A318/A319/A320/A321

SERVICE BULLETIN REVISION TRANSMITTAL SHEET

**TITLE: FUSELAGE - REAR FUSELAGE - APPLY COLD WORKING AND
REPLACE RIVETS IN THE POTABLE WATER SERVICE PANEL AREA
AT S18**

This page transmits Revision No.02 of Service Bulletin No.A320-53-1272

Figure A-SBAAA - Sheet 01
Replacement of the solid rivets, FR65 to FR66.

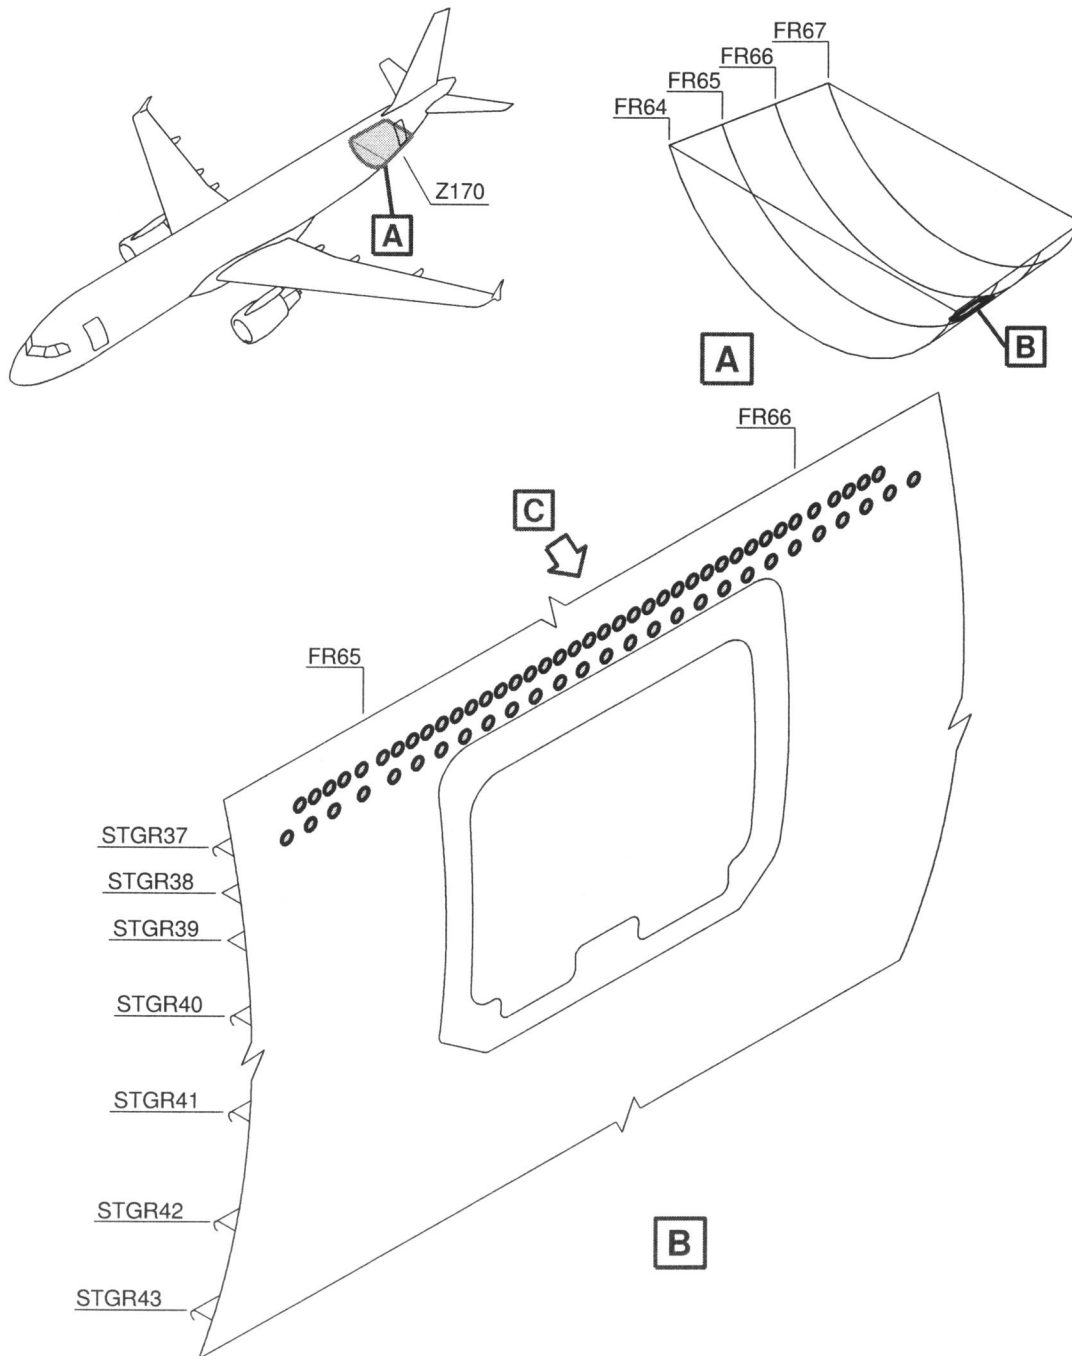
- (a) Remove the fasteners above the door in accordance with SRM 51-42-00 and refer to Fig. A-SBAAA Sheet 01 and Fig. A-SBAAA Sheet 02.

(a) Do a rotating probe inspection on the holes of the removed fasteners, refer to NTM Task 51-10-01-250-801 and refer to Fig. A-SBAAA Sheet 01 and Fig. A-SBAAA Sheet 02.

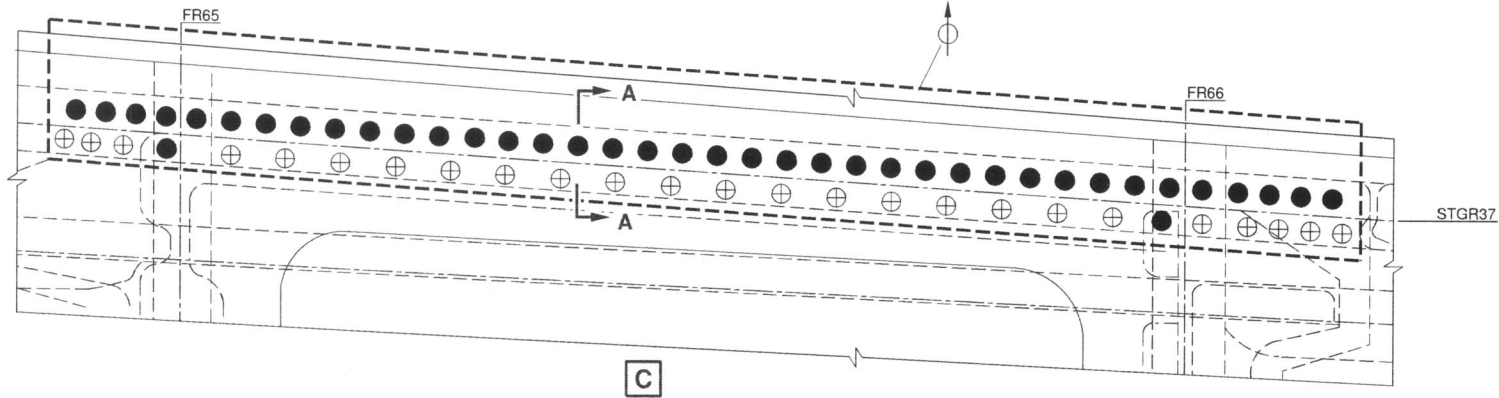
1 Oversize the holes to the starting hole diameter given in Fig. A-SBAAA Sheet 02

6 Ream the holes to the final hole diameter given Fig. A-SBAAA Sheet 02

- (a) Install the new fasteners in accordance with SRM 51-42-00, refer to AMM Task 20-21-11-911-001 and refer to Fig. A-SBAAA Sheet 02:
